COMPONENTS OF CONTRACT PLANS SET
ROADWAY PLANS
SIGNING AND PAVEMENT MARKING PLANS
SIGNALIZATION PLANS

STATE OF FLORIDA
DEPARTMENT OF TRANSPORTATION
FINAL "AS-BUILT" PLANS
CONTRACT PLANS

FINANCIAL PROJECT ID 197374-2-52-01
POLK COUNTY (16100)
STATE ROAD NO. 546

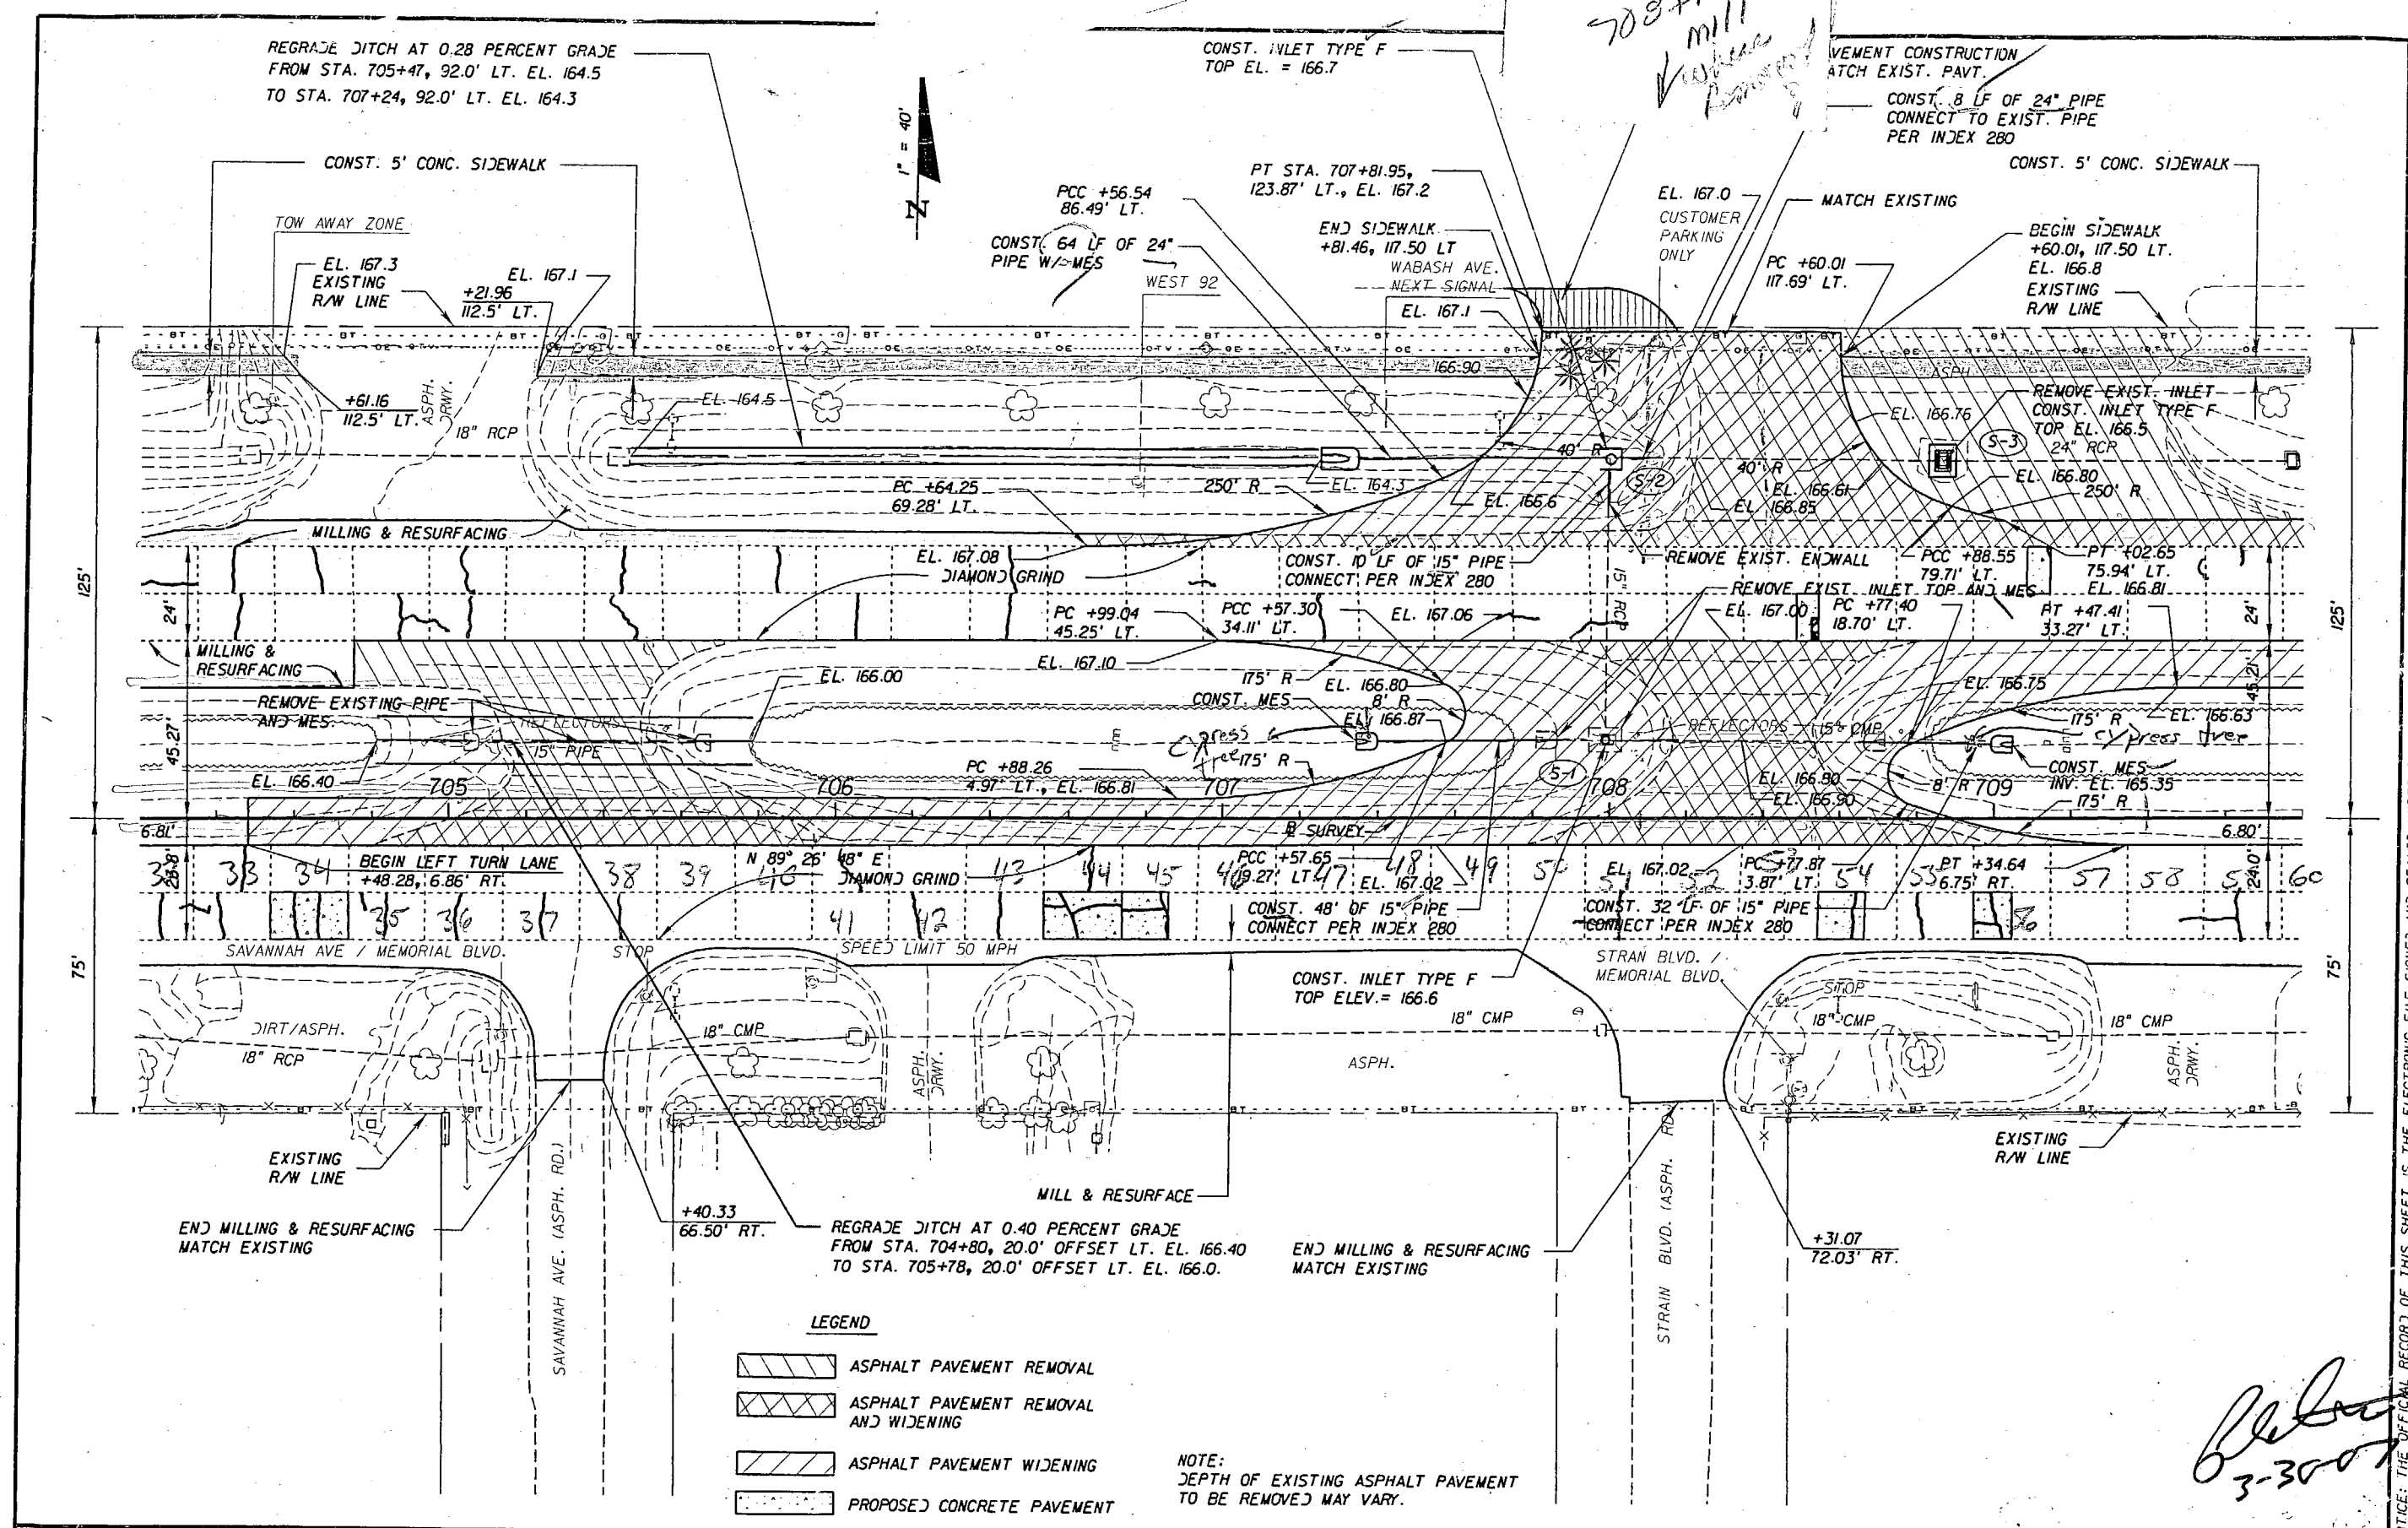
FB0003
 PG 40
 708+10
 mill

"AS-BUILT" PLAN SHEET	
SHEET NO.	27

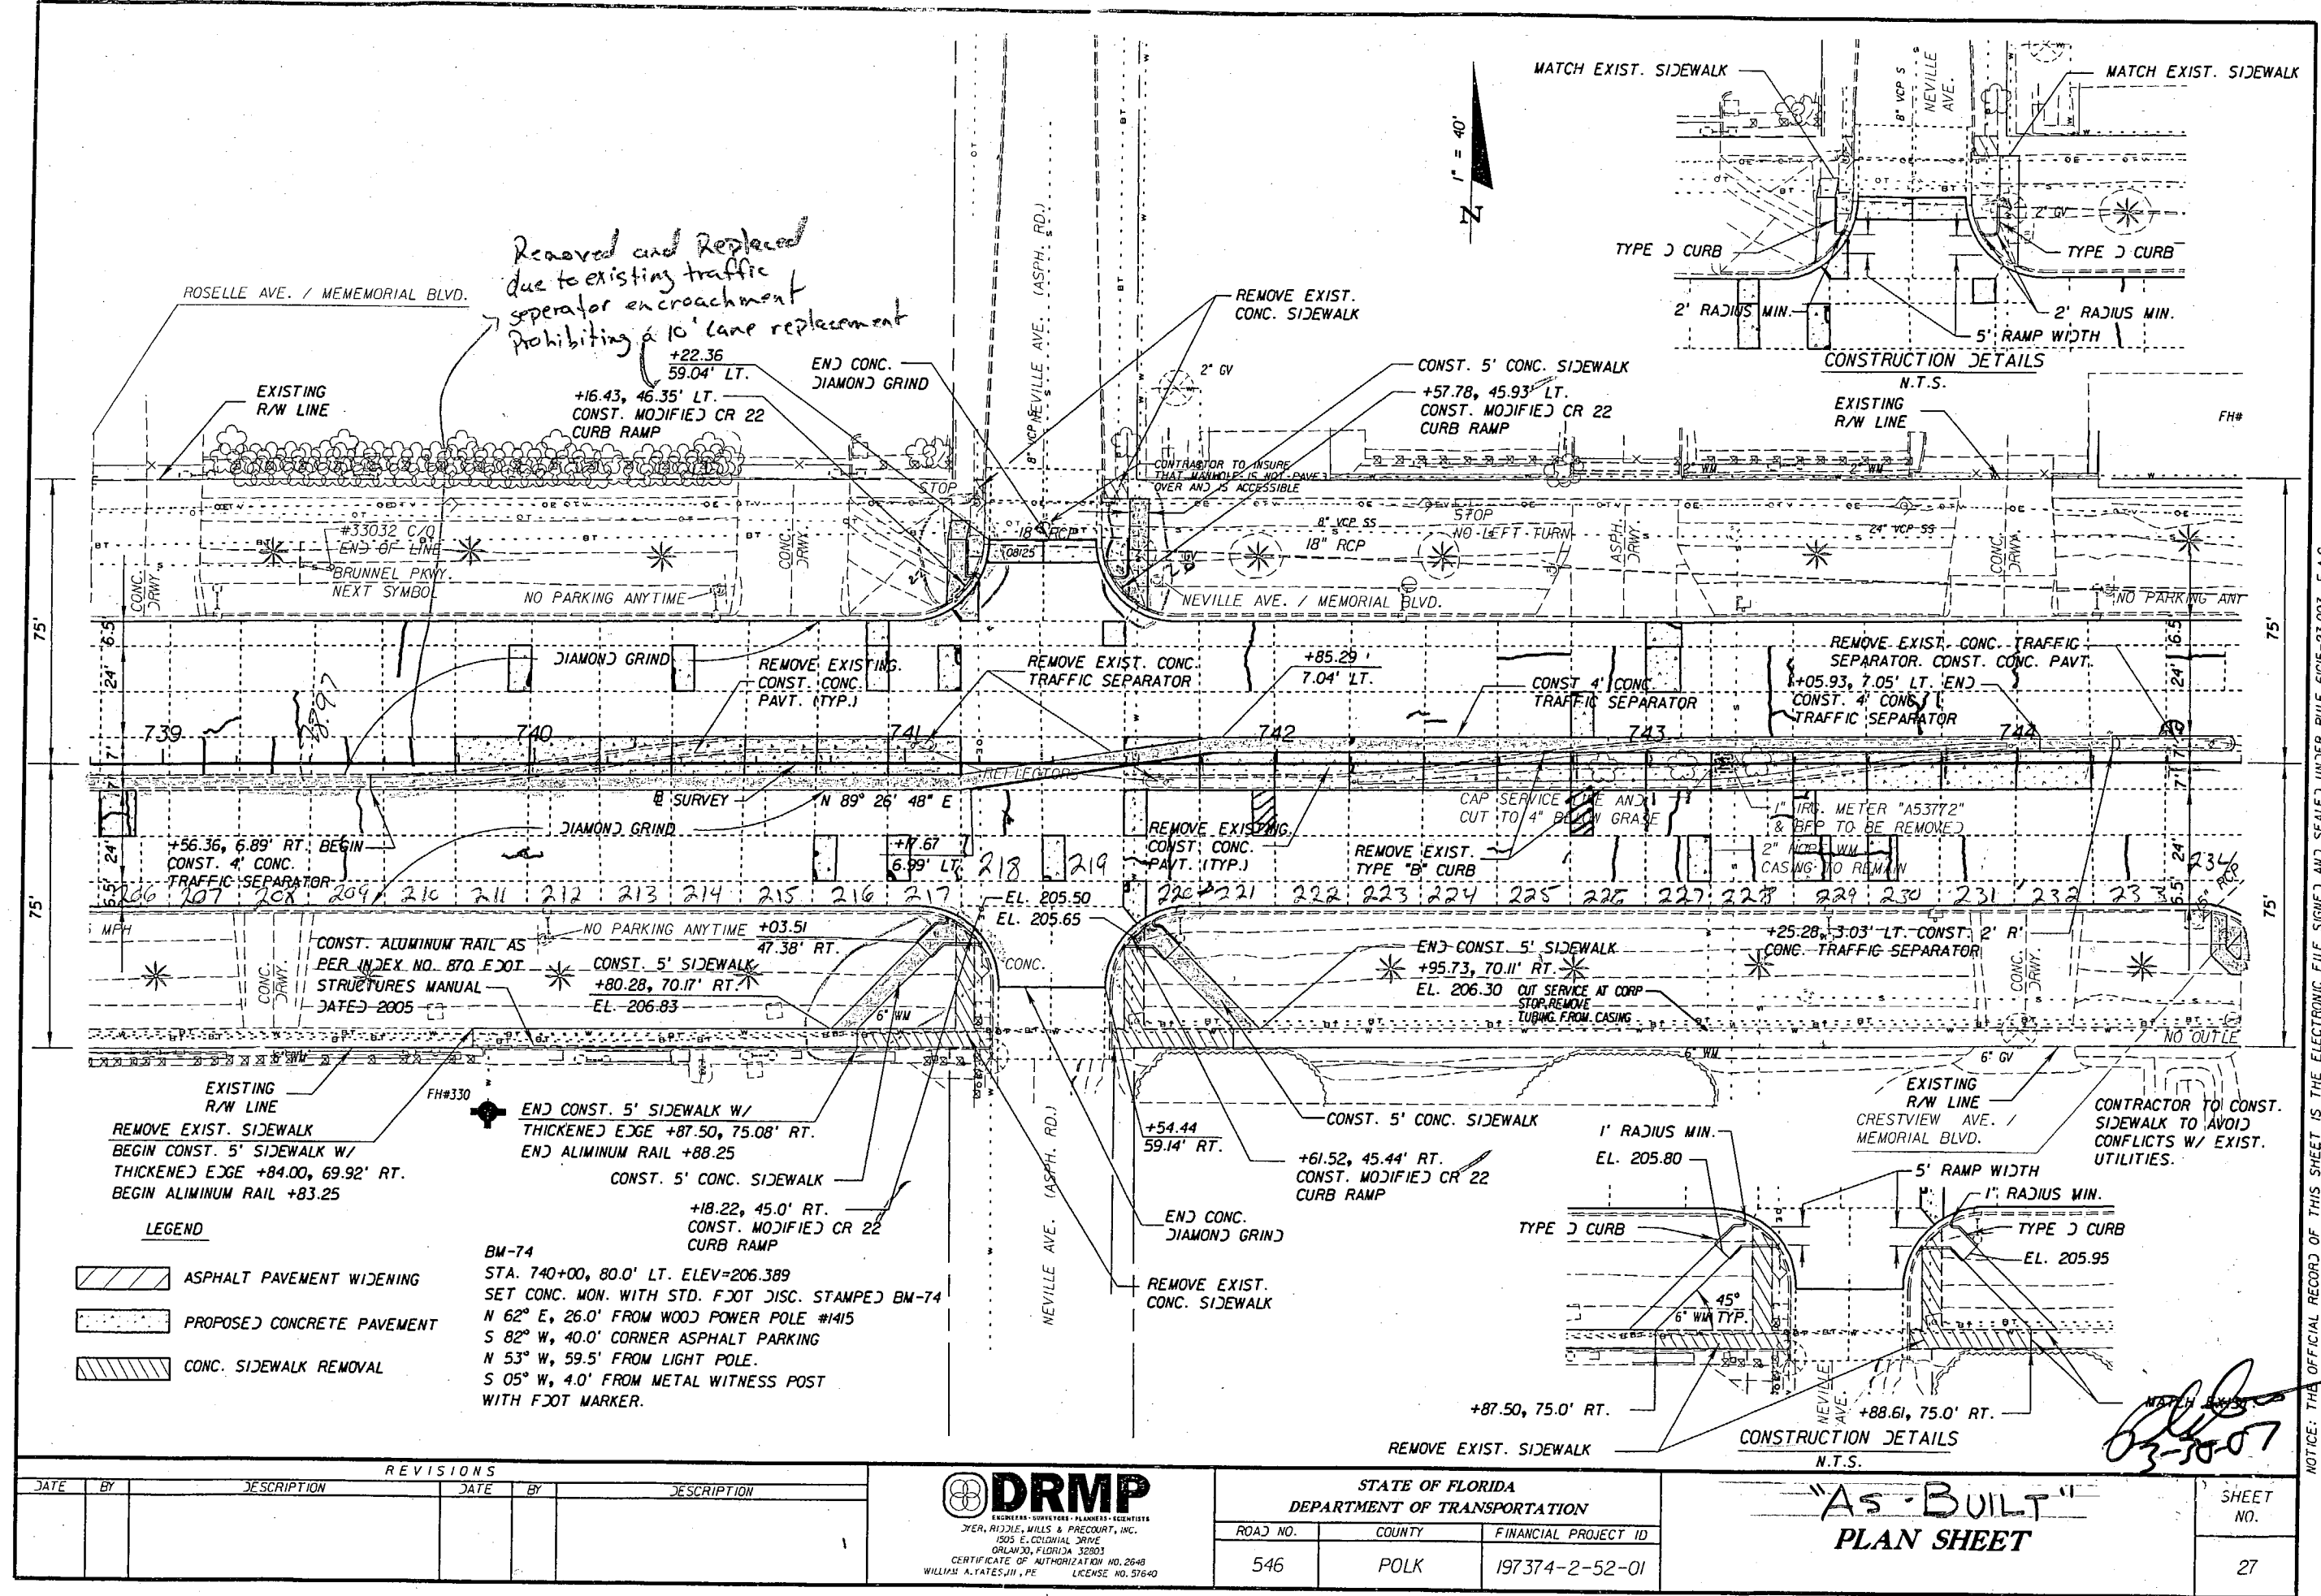
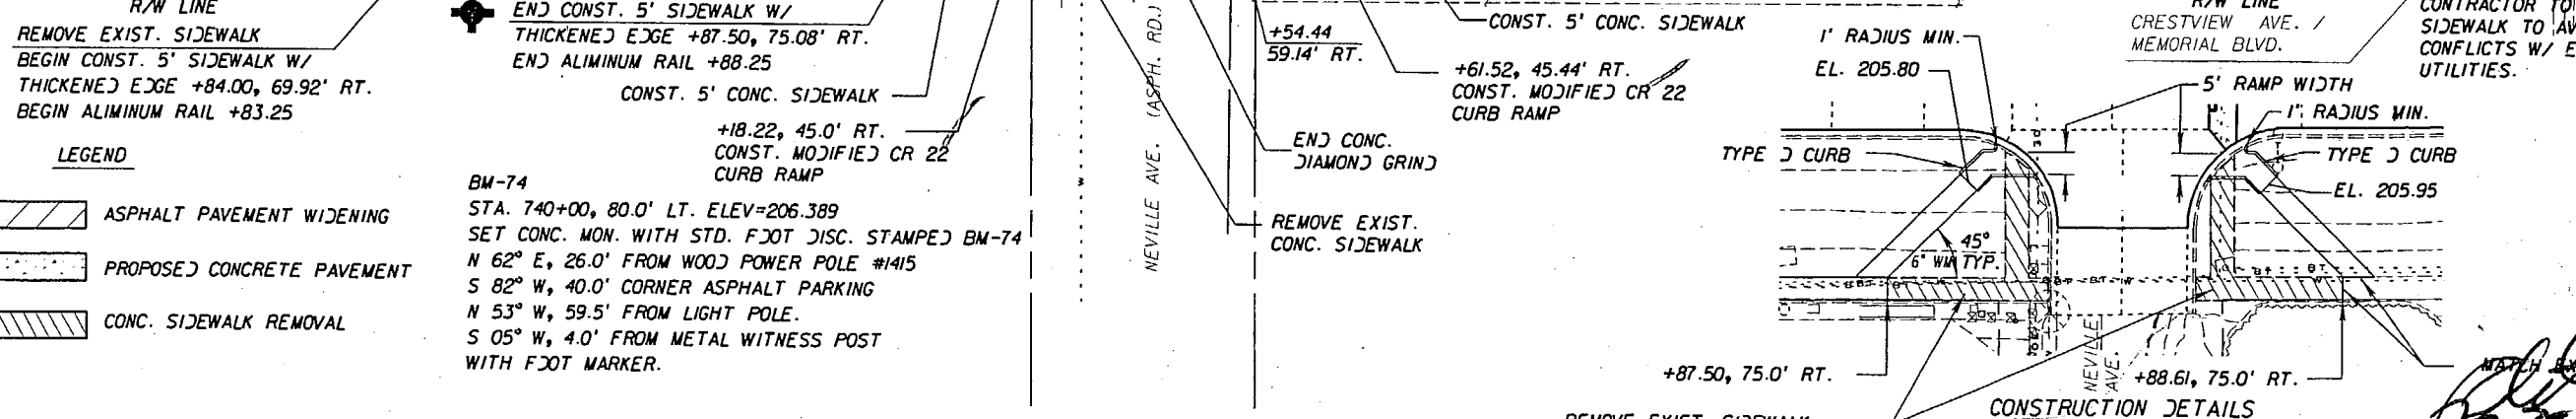
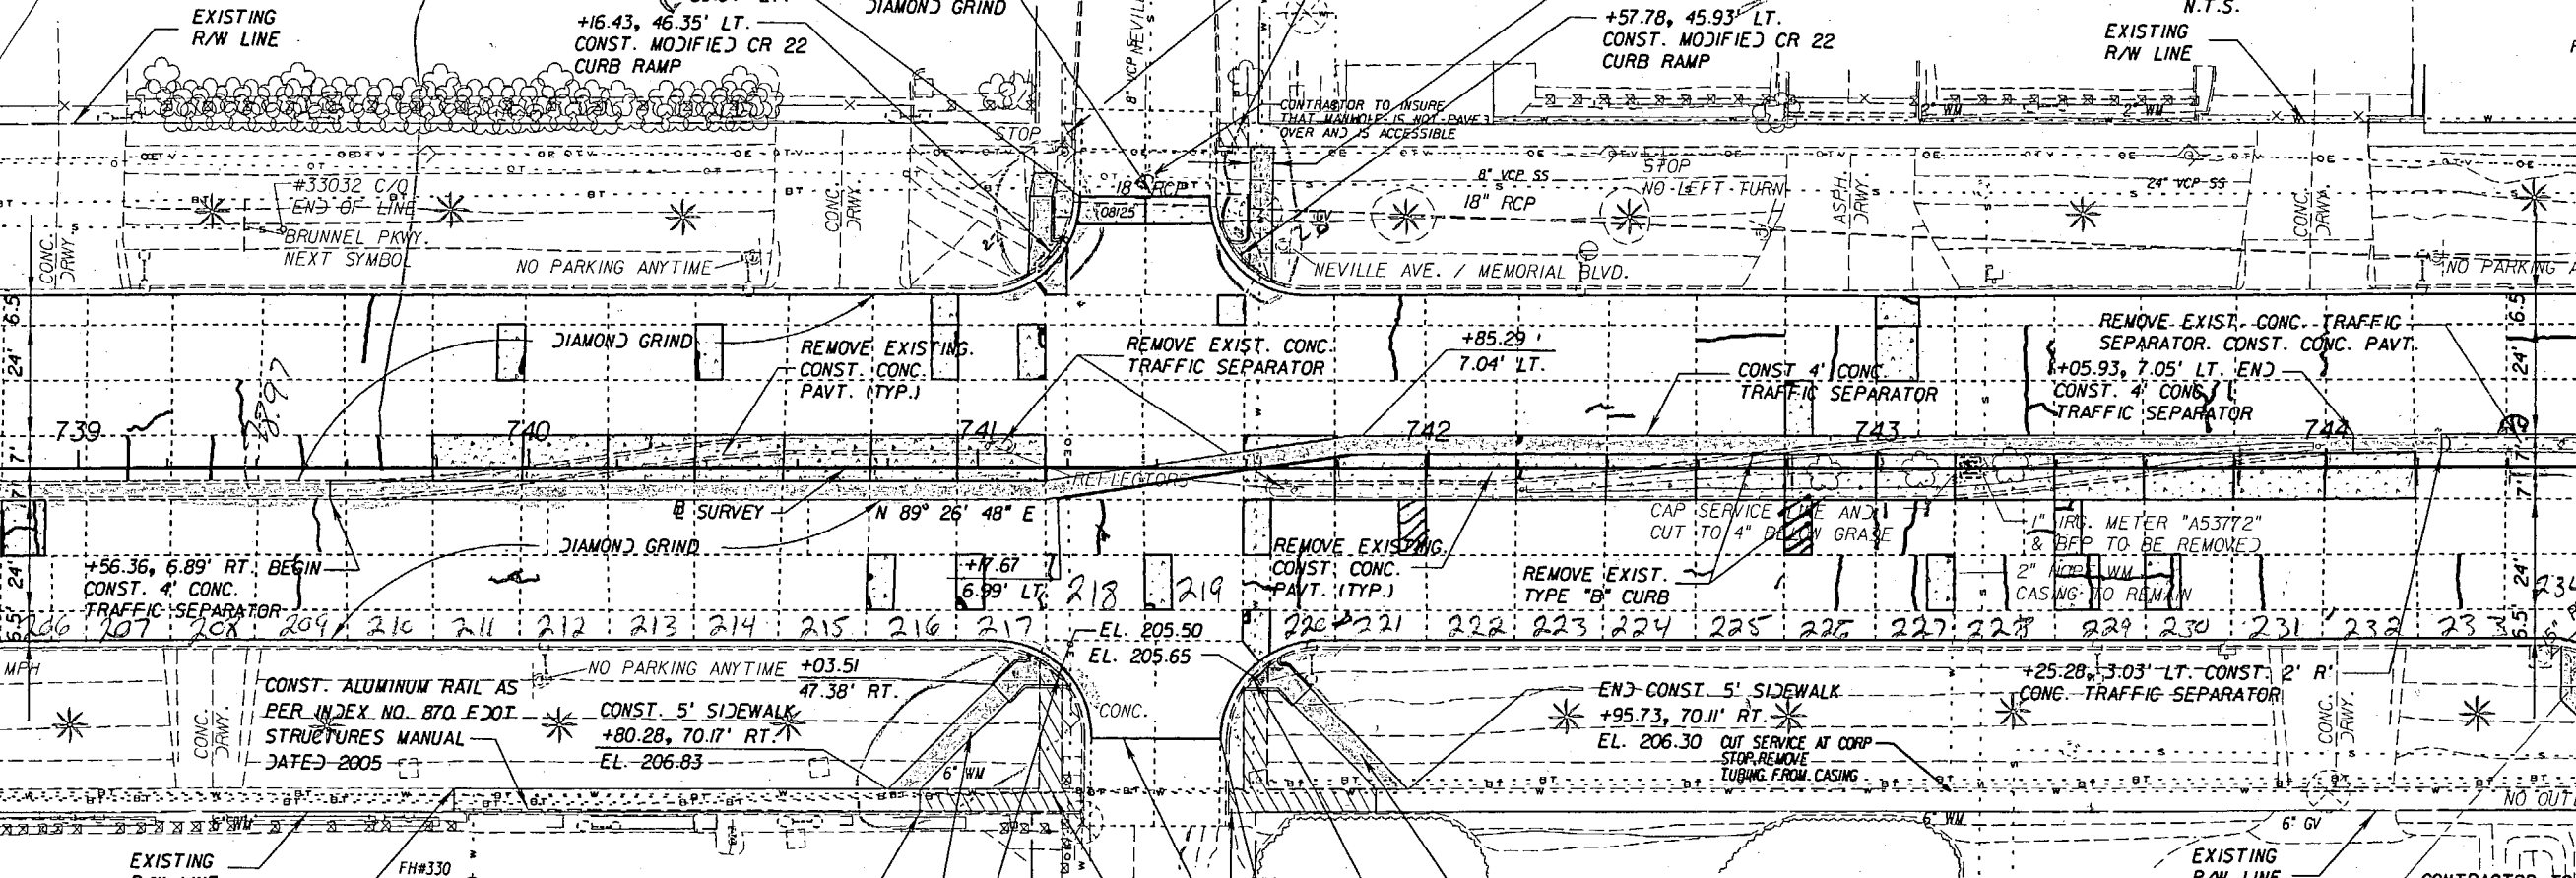
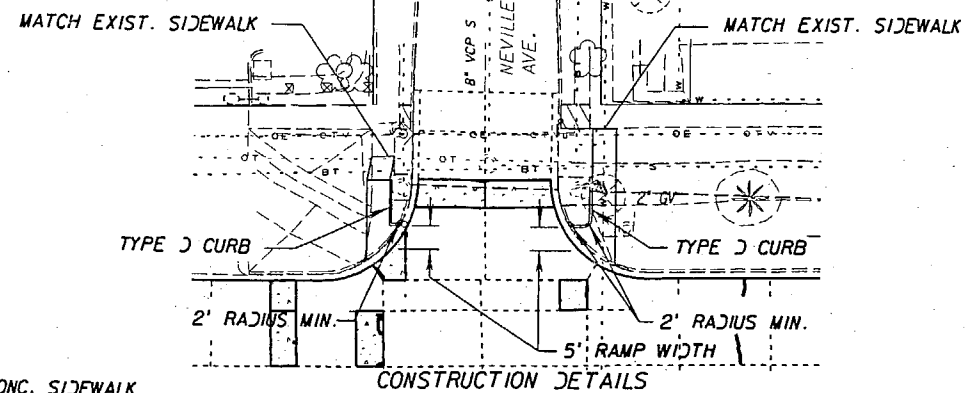
Removed and Replaced
due to existing traffic
separator encroachment
prohibiting a 10' lane replacement
